Date of Issue: October 2007

Affected Publication: API Standard 685, *Sealless Centrifugal Pumps for Petroleum, Heavy Duty Chemical, and Gas Industry Services*, First Edition

ERRATA

Figure 7—Speed-Torque Curve

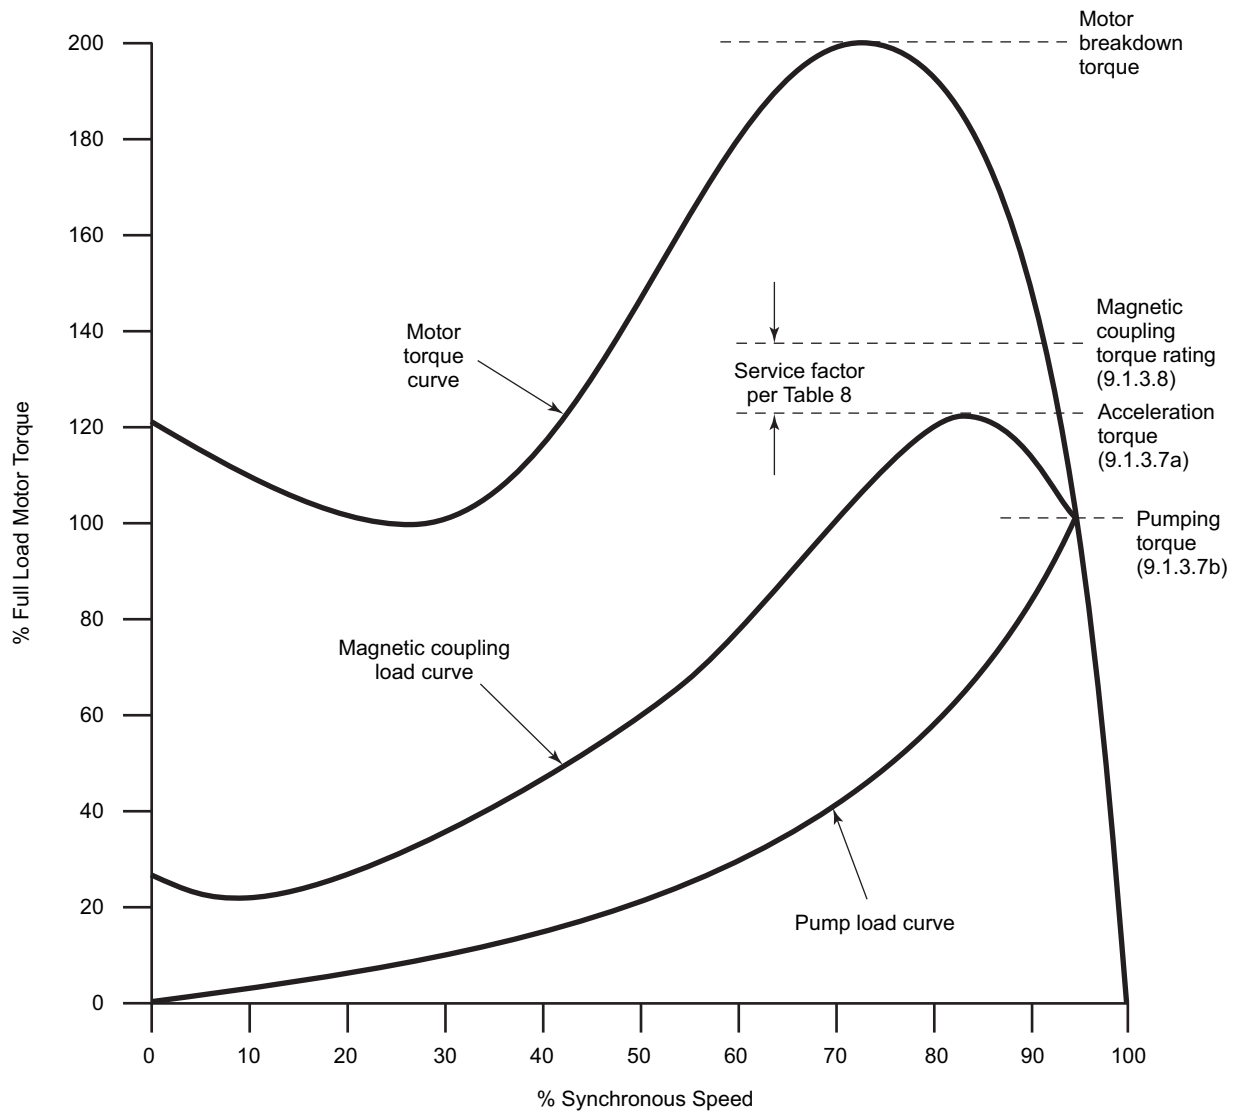
*On page 33, replace **Figure 7—Torque Curve** with the attached.*

The references have been updated as follows:

Service factor per Table 5-1

to

Service factor per Table 8

Magnetic coupling torque rating (5.1.3.8)

to

Magnetic coupling torque rating (9.1.3.8)

Acceleration torque (5.1.3.7a)

to

Acceleration torque (9.1.3.7a)

Pumping torque (5.1.3.7b)

to

Pumping torque (9.1.3.7b)
